JONAS & ASSOCIATES INC.  
Environmental Consultants

<b>Date:</b> 7 / 18 / 1997	<b>Project:</b> Paco 9201 SL
<b>Time:</b>	<b>Project #:</b> PCO-220

<b>From:</b> Mark Jonas	<b>of:</b> J&A	<b>FAX #:</b> (925) 933 - 5362
<b>To:</b> Eva Chu	<b>of:</b> Alameda County Health	<b>FAX #:</b> (510) 337 - 9335
<b>Date:</b> 1 / 10 / 2000	<b>Project:</b> Former Paco Pump, Oakland	
<b>Time:</b>	<b>Project #:</b> PCO-220	
<b>Attachments:</b>		
1) Previous Documents on PCB Issue		
2)		
3)		
<b>Number of Attached Pages (not including transmittal page):</b>		<b>14</b>

Date: 8-1-1992	Figure 4-5	Drawing Number PC0220-8/92:F4-5
Locations Approx.

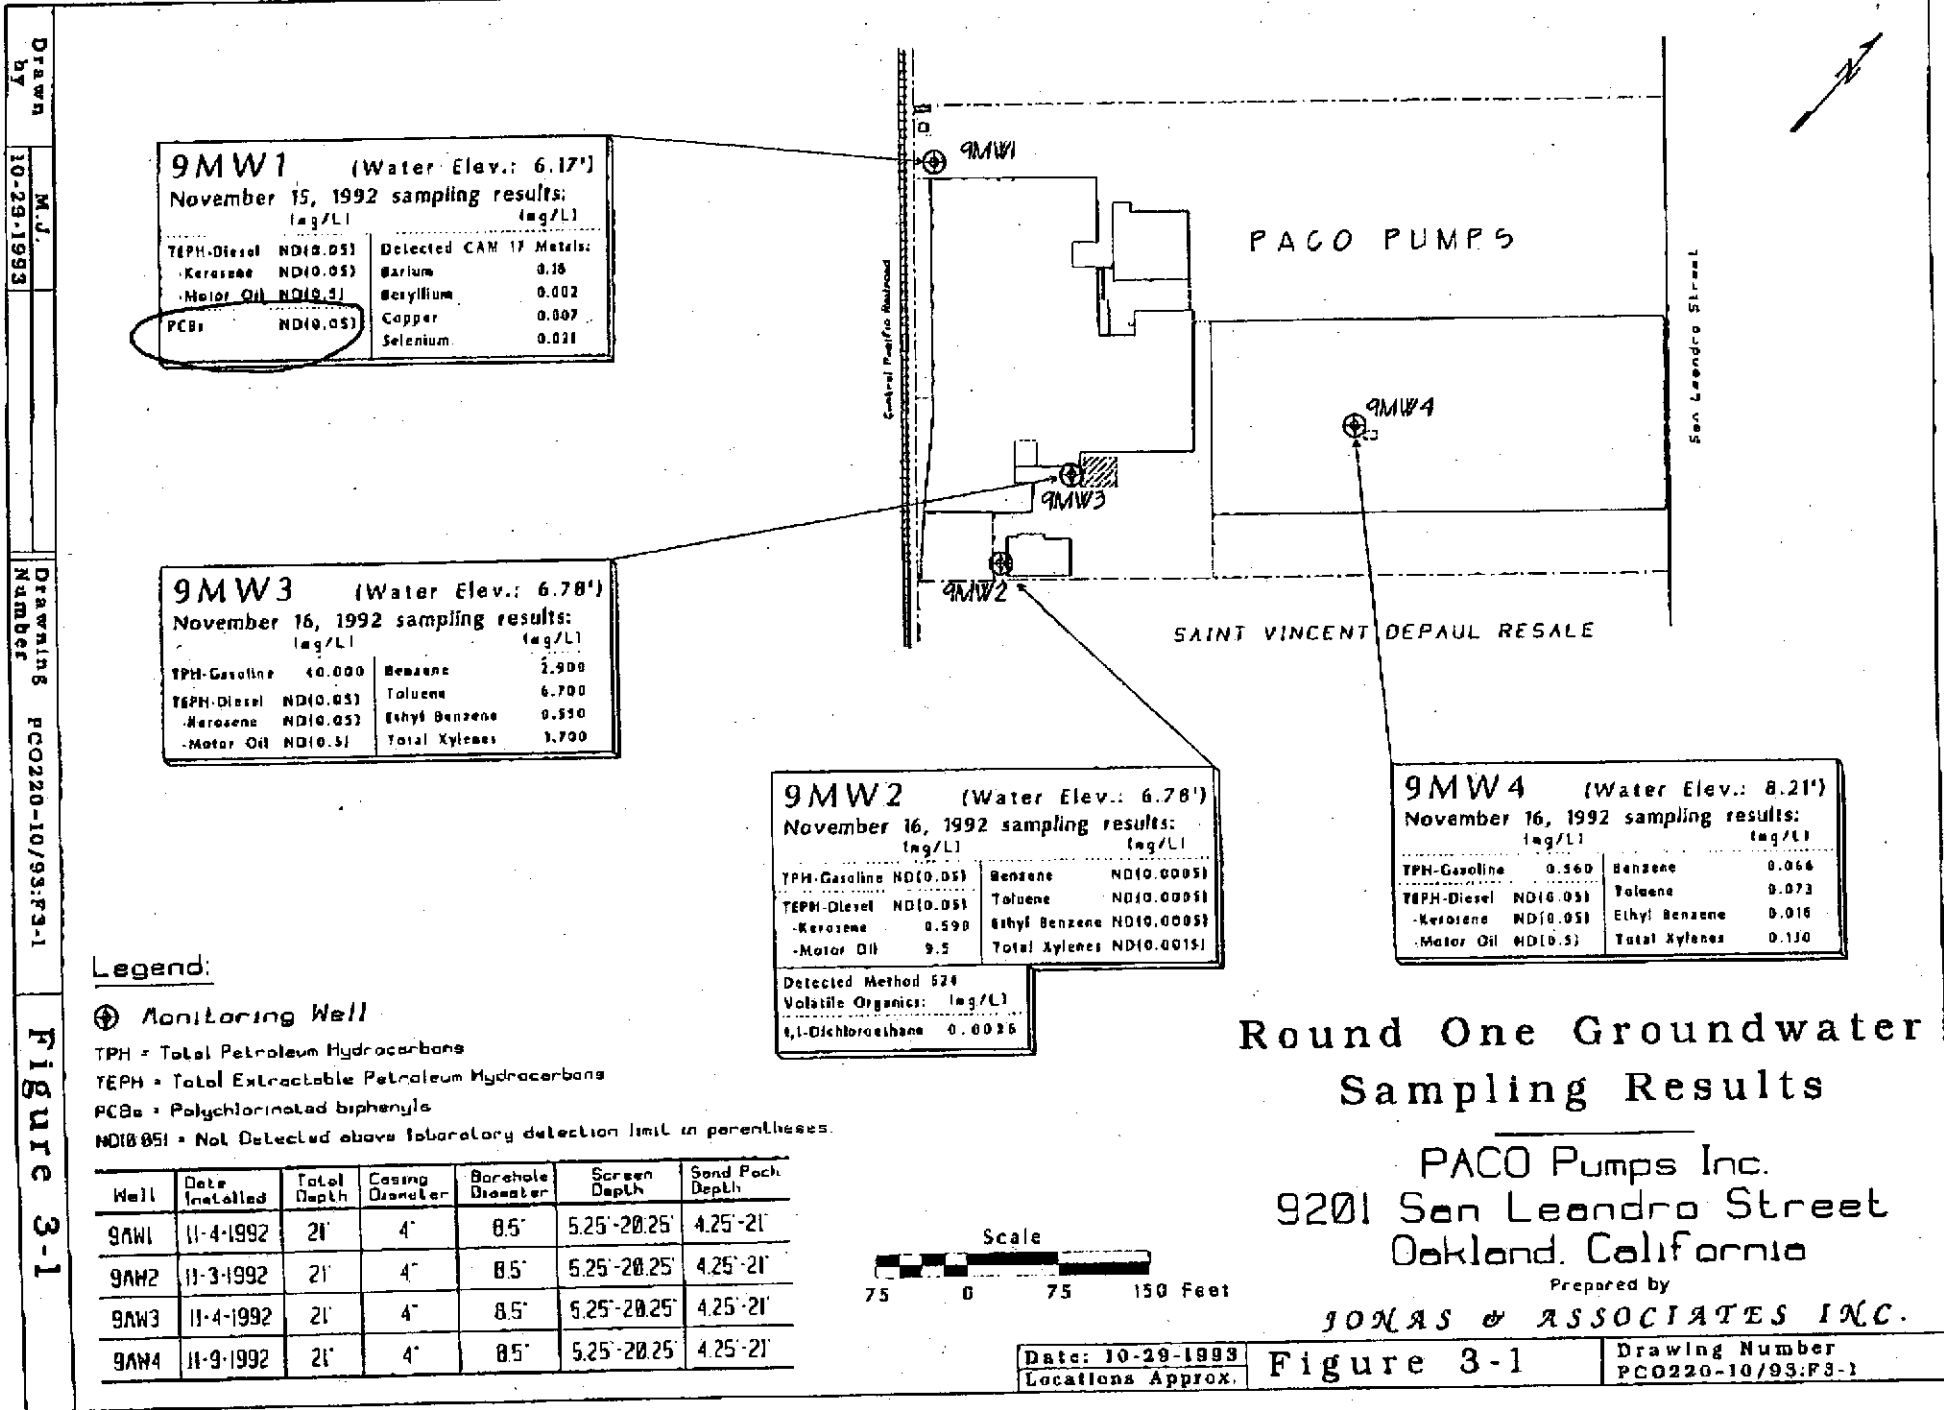
**I am attempting to understand the rational for excavation of soil in the area of boreholes B6 and B7. Samples collected on October 1, 1991 detected 0.400 mg/kg (B6) and 0.670 mg/kg (B7). These concentrations are both below federal cleanup limits of 10 mg/kg (1987 - 40 CFR 761) and 50 mg/kg (1992 - 40 CRF 761).**

**Assuming that we do need to excavate soil in this area, what is the rational for the excavation activity?**

Figure 3-1

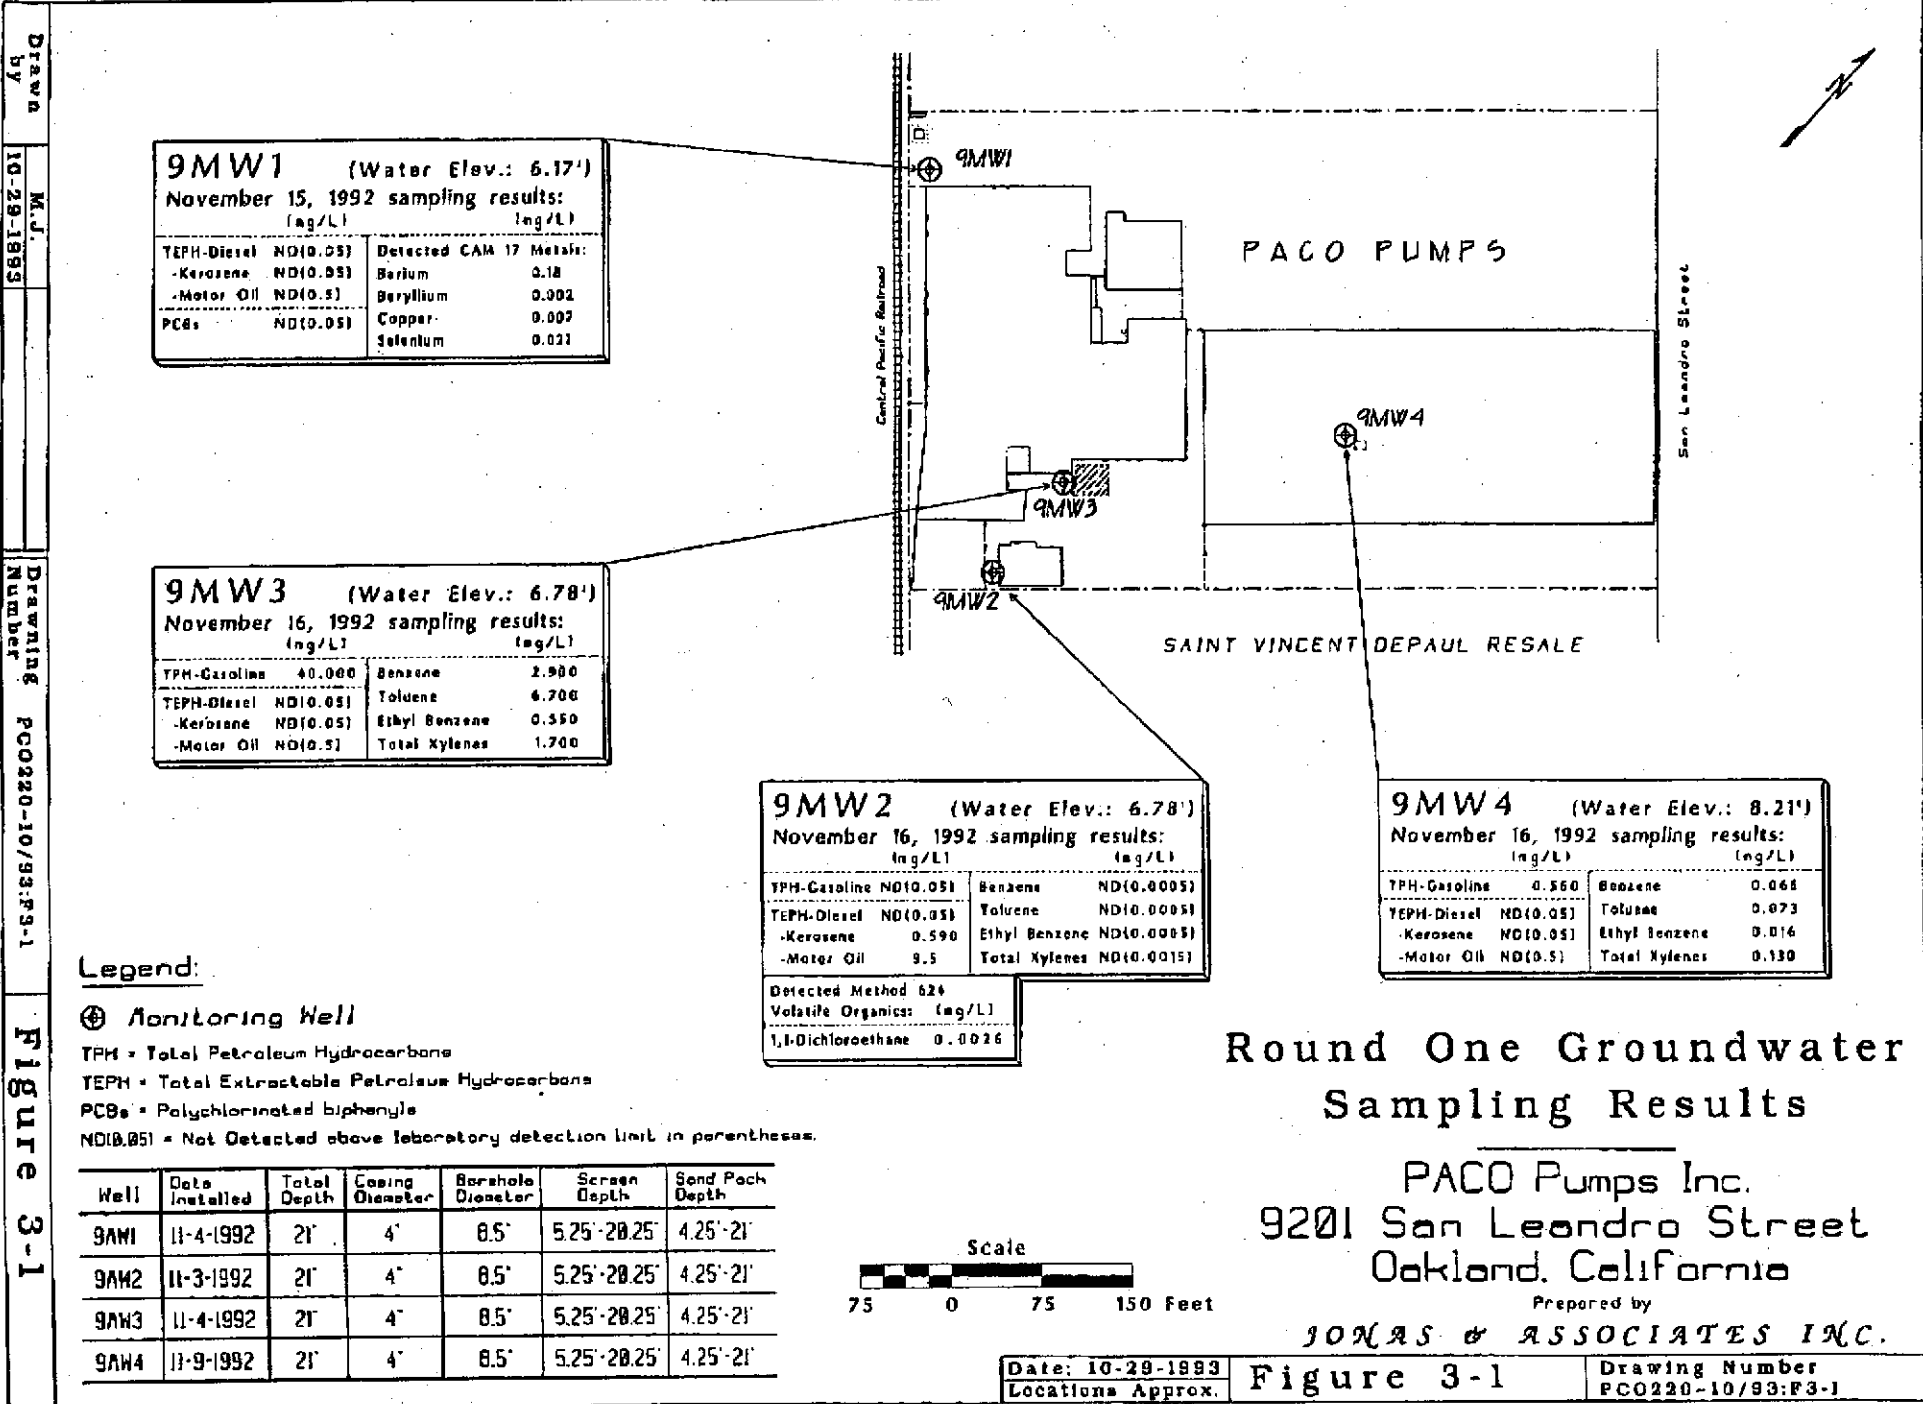
- » PCB at 0.670 mg/kg at B7 (0-0.5')
- » PCB at 0.400 mg/kg at B6 (0-0.5')
- » Monitoring Well MW-1 soil samples (11/4/92):
  - 5' - PCB 0.29 mg/kg
  - 10' - PCB ND(0.1)
  - 15' - PCB ND(0.1)
- » PCB ND(0.05) mg/L groundwater sample Monitoring Well MW-1, sampled 11/16/92
- » PCB ND(0.05) mg/L groundwater sample Monitoring Well MW-1, sampled 3/9/93
- » CFR Part 761, Subpart G - PCB Spill Cleanup Policy  
Uses a 50 mg/kg PCB cleanup level (see attachment for details)
